# LOHAN ANDERSON

## MEMORANDUM

ATTN:	Craig M. Failor – Oak Park Village Planner
FROM:	Floyd D. Anderson
DATE:	6 July 2015
REGARDING:	<b>Oak Park Station Development – Architectural Review</b>
DISTRIBUTION:	Bill Boznos – LA; File

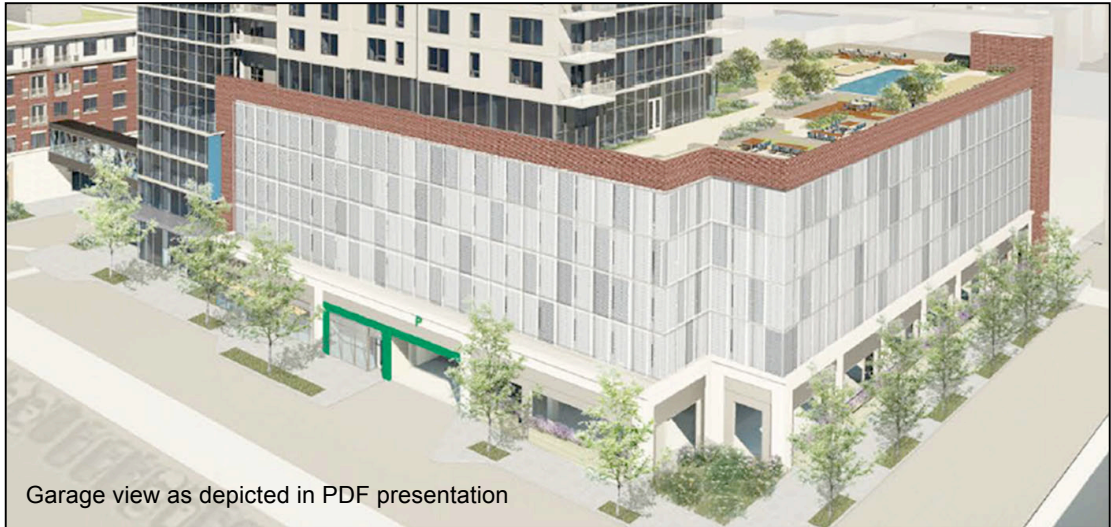
In the July 2<sup>nd</sup> Plan Commission meeting one of the Commissioners expressed concern over the look of the painted metal panels proposed for the garage façade. I think that the three tones of grey suggested for the coloring, and as shown in the most recent rendering (see below), do not suggest a very interesting or inspired façade. However, **I do not have any objection with the use of this panel** nor the idea of coloring. The animation of the development depicted a palette of blues and more correctly depicted the mosaic of individual panels that will have open shadows between the panels. So, the use of color and the dual patterns of the perforated holes plus the panels themselves, I think can create a perfectly acceptable and interesting façade. Reference Attachment A and the items listed below.

Recommendation 3 – I would encourage the architect’s to refine this cladding proposal, perhaps with more colors and to submit revised drawings and renderings. Secondly I question the use of the brick band along the top of the garage. While the architect’s may have been using it to visually separate the garage from the tower, I think the metal panels and the mass of the garage itself do that quite well. I would also suggest that the Village require that these panels be aluminum. The architect’s have indicated that the intent is to use aluminum but it would be most unfortunate if they were later value engineered to ferrous metal which no matter how well coated will probably start to rust.

# ATTACHMENT A

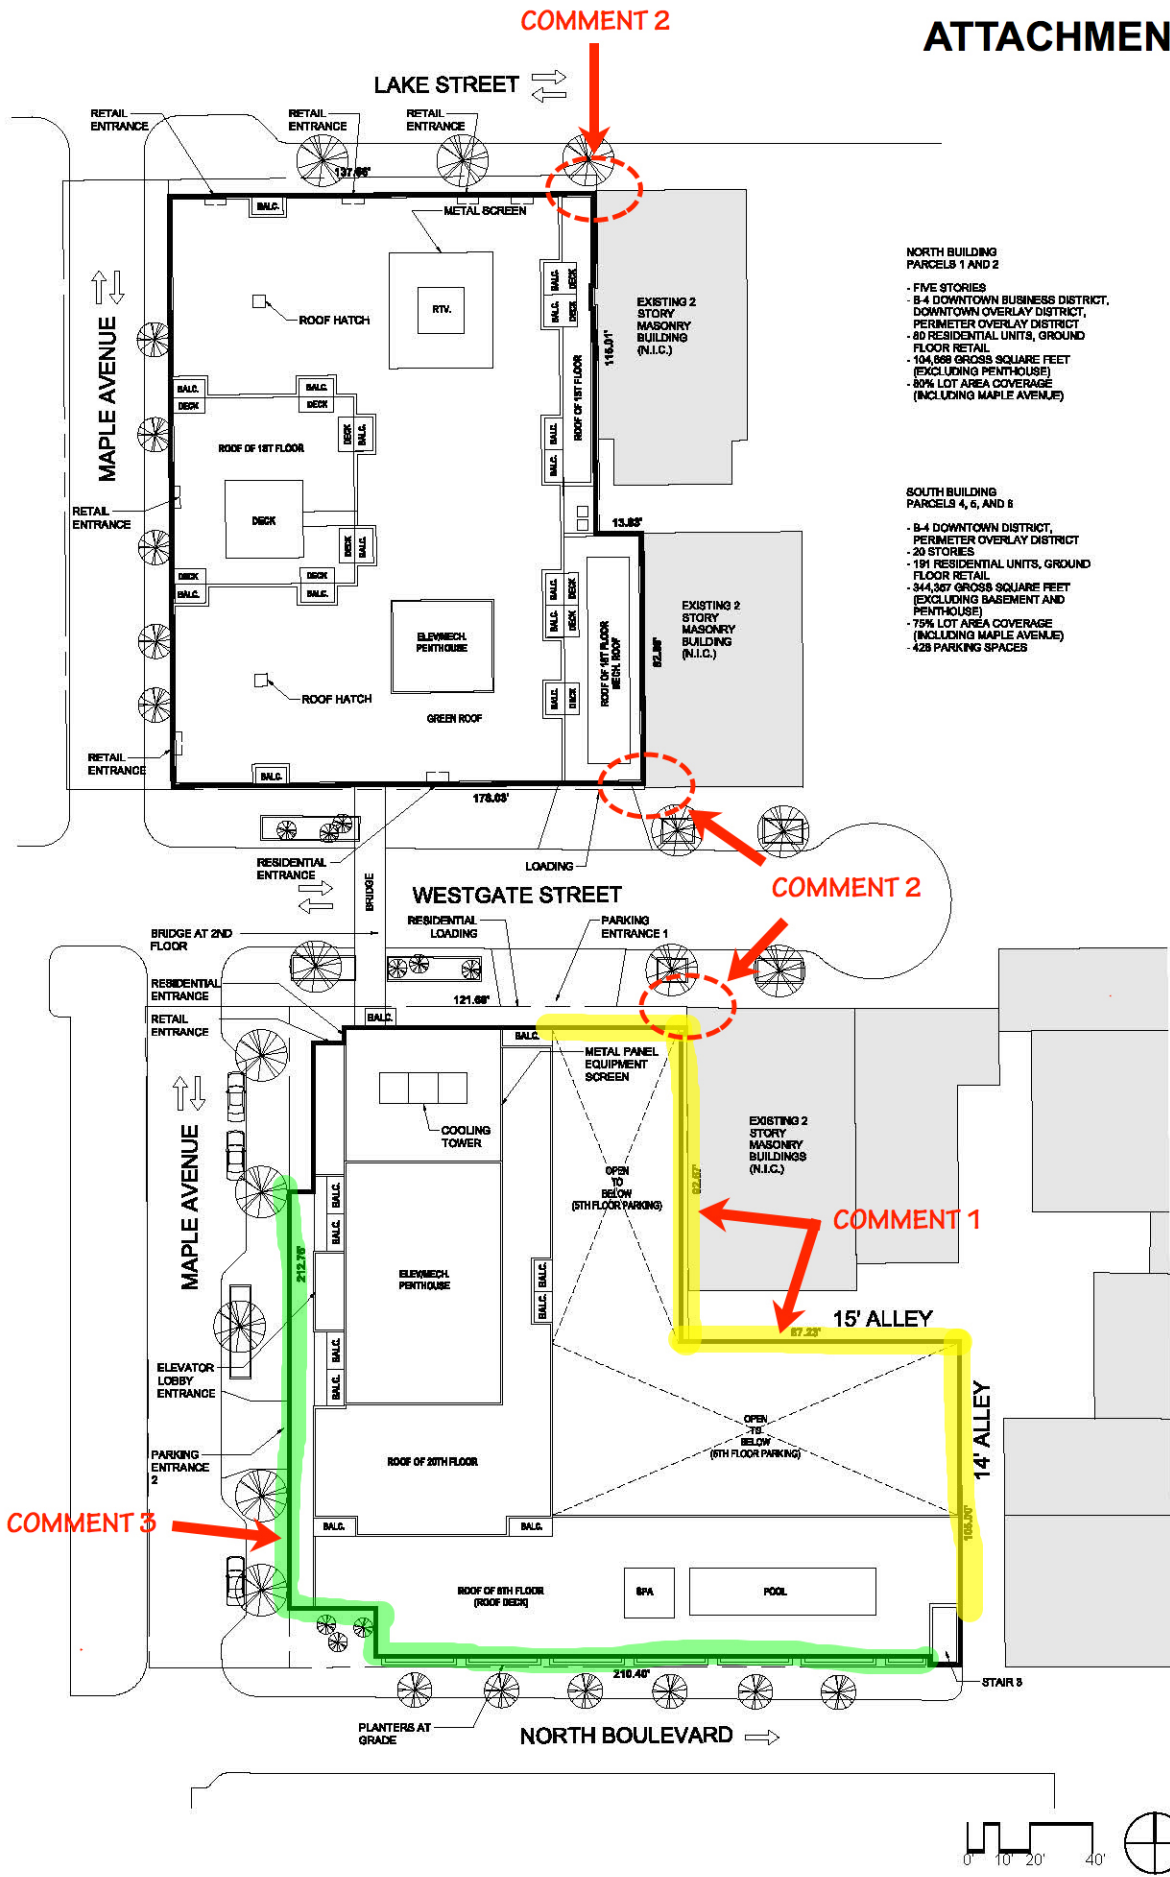
Beginning at the public alley that is adjacent to east side of this block, and continuing along the 15 foot wide alley on this block, there is an open garage. **The materials are exposed structural concrete and block in-fill.** This portion of the development will be visible along the Elevated tracks and somewhat visible from North Boulevard. The building to the east of this south block is lower than the garage plinth and does not have views oriented toward the garage but any future development on the adjacent property could choose to have views toward this garage. The parking plinth also terminates at two different heights due to the internal layout and therefore does not have a consistent horizontal termination (top). **This openness and stepped top gives this façade a raw and unfinished appearance that is inconsistent with the rest of the development’s design and finishes.** Reference Attachment A and the items listed below.

There are three locations where the new construction immediately abuts existing buildings; 1) Lake Street, 2) North side of Westgate St. and 3) South side of Westgate St. In all locations there is not enough information to judge how well the façade design of the new construction is coordinated with the existing. In all locations the existing buildings have some strong architectural features and styles that should be considered and coordinated with any new design. Reference Attachment A and the items listed below.

Recommendation 1 – This façade (along both alleys) should be clad with materials and a design that is compatible with the rest of the development.

Recommendation 2 – These three areas should be studied relative to the existing context and the design adjusted as is appropriate. Revised elevation drawings and/or other exhibits should be submitted for review.
